N.A.Z. Bangladesh Ltd. (10232)

15.MAY.2014

Identified Priority 1 Concerns

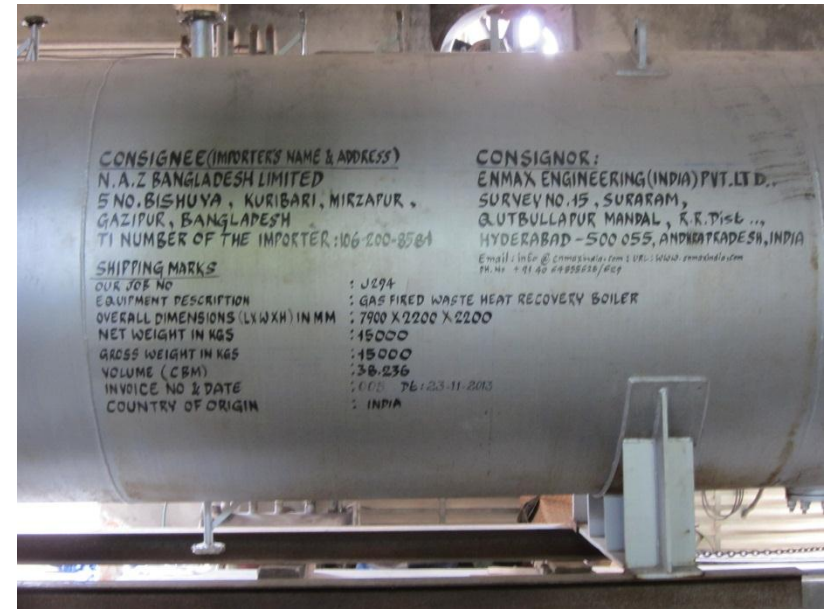
Steel column supporting the ventilation platform is buckled. The column should be replaced and a capacity check should be carried out.

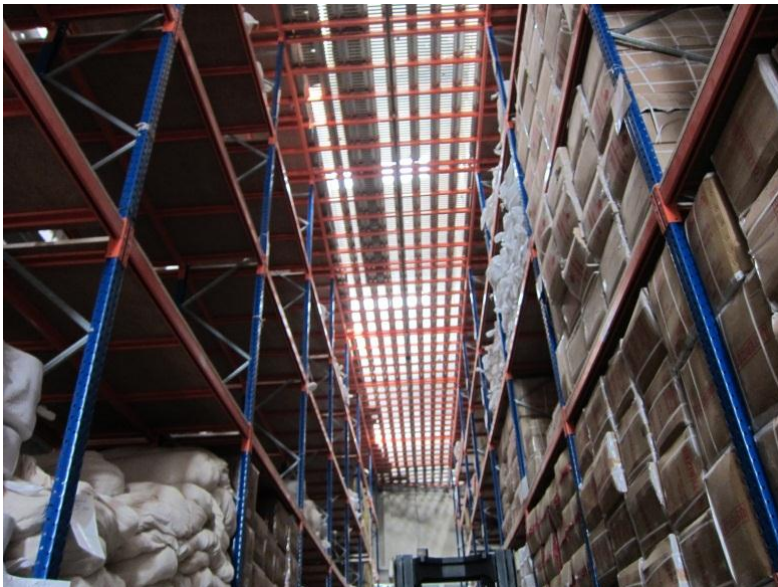
Two span of continuous 150 mm thick slab (5.50x6.50 m) is currently used for the new 15 tons heat exchanger on 1st floor of Utilities building. Capacity check should be carried out.

Steel connection of spiral staircase and balustrade of ETP are not attached to the reinforced concrete structure.

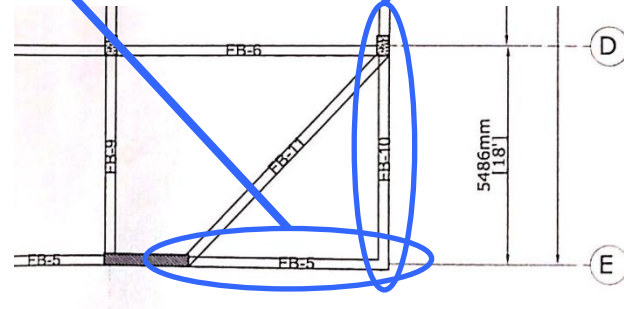
Customized steel racking system is used for storage with an upper platform over the entire area. Some horizontal frame are sagging. A capacity check should be carried out.

Capacity check of these beams should be carried out.

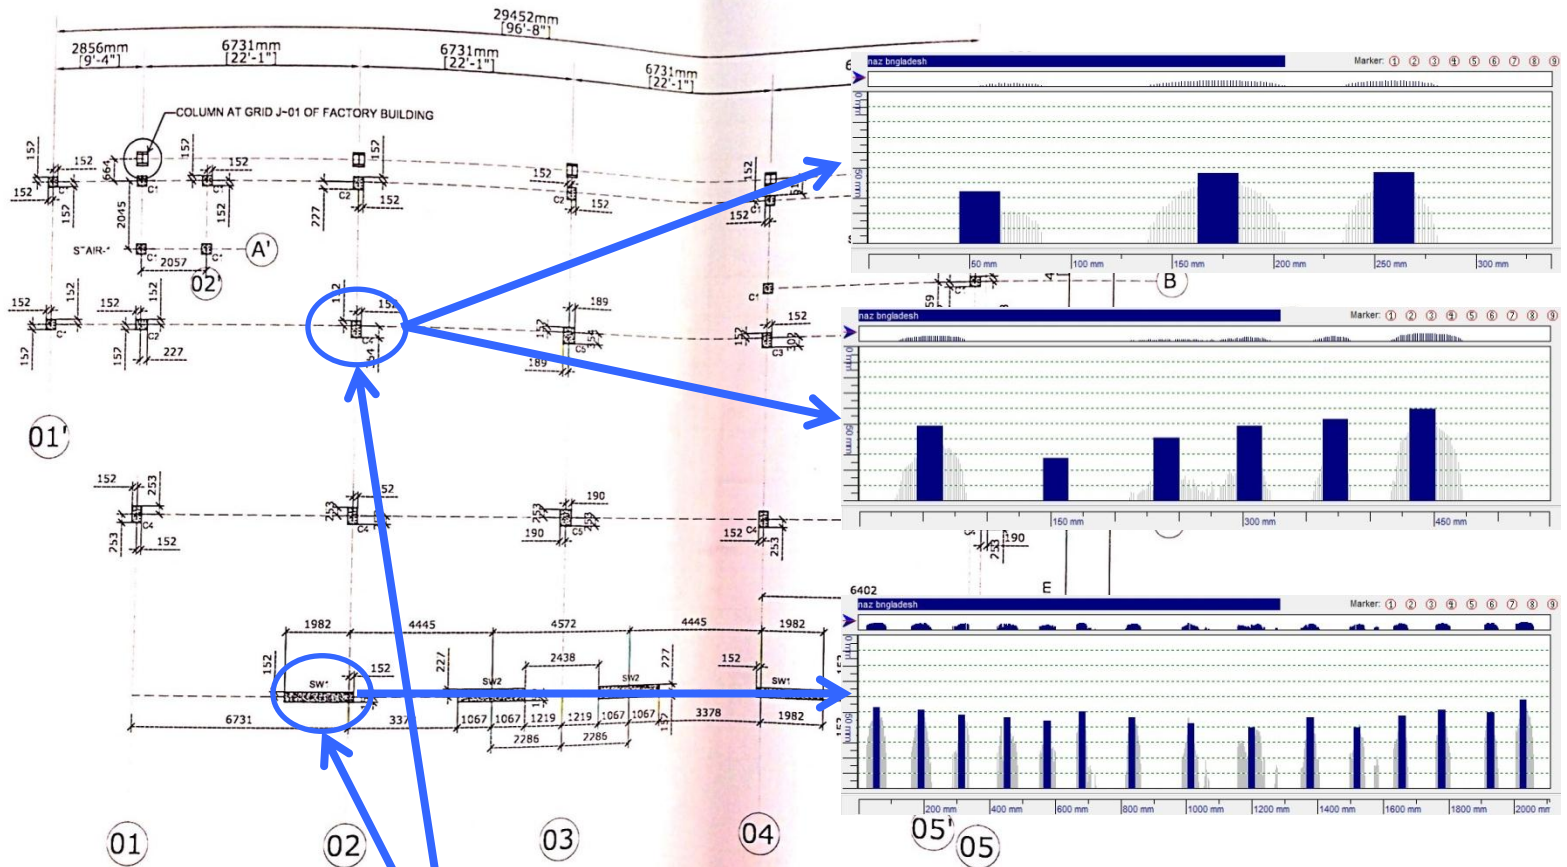
The drawings do not show any of steel staircase, ventilation platform and connecting bridge.

The no. of reinforcement of C4 and SW1 are less than what are shown in the drawing.
